APPLICATION NO.	FILING DATE	FIRST NAMED INVENTOR	ATTORNEY DOCKET NO.	CONFIRMATION NO.
10/580,736	05/25/2006	Kim Ki Bong	1991.75205	9362
24978 GREER, BURN	7590 02/10/200 NS & CRAIN	EXAMINER		
300 S WACKER DR			HAWK, NOAH CHANDLER	
25TH FLOOR CHICAGO, IL 60606			ART UNIT	PAPER NUMBER
			3636	
			MAIL DATE	DELIVERY MODE
			02/10/2009	PAPER

DETAILED ACTION

Capshaw, Figure 3

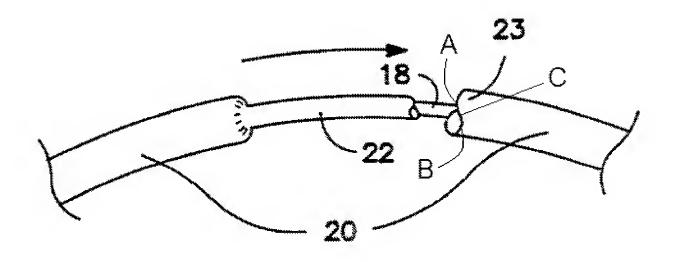
4. Claims 1-7 are rejected under 35 U.S.C. 103(a) as being unpatentable over Joo-Tai in US Patent 6286531 in view of Capshaw in US Patent 5435024. Joo-Tai teaches a collapsible tentpole (1) comprising: a series of hollow shafts (2) connected by insertion into each other (See Figure 2b); and an elastic cord (5) having two ends (6) arranged in the shafts with both said ends secured to the two endmost shafts (at 3' in Figure 1, for example). Joo-tai further teaches a sleeve tube (7) secured to the end of one shaft. Jootai fails to teach a groove on the end of the shaft. Capshaw appears to teach a collapsible tent pole having a series of hollow shafts (20) connected by insertion into each other (See Figure 3), wherein at least one groove (B) is arranged on at least one end of the shaft, that the groove is shaped into a smooth arcuate configuration (Best seen in Figure 3), that the end of the shaft and sleeve are of a wave configuration and the wave bottom (B) forms the groove. Capshaw teaches that a ring end of the shaft or the sleeve tube is diagonal (C), and a bottom of the diagonal ring end (B) together with the hollow interior of the shaft or the sleeve tube forms said at least one groove. Capshaw also teaches that the groove is a two-section groove with an upper section including two downwards extending arcs (A) and a lower section including two grooves (B) that extend downwards from the bottom of the upper section. It would have been obvious to one of ordinary skill in the art at the time of invention to modify the device of Joo-tai by adding at least one groove as taught by Capshaw to the sleeve tube in order to provide a more flexible insertion engagement for the tubes, insofar as the grooves

would provide a user to press them together and create a frictional fit between the tubes.
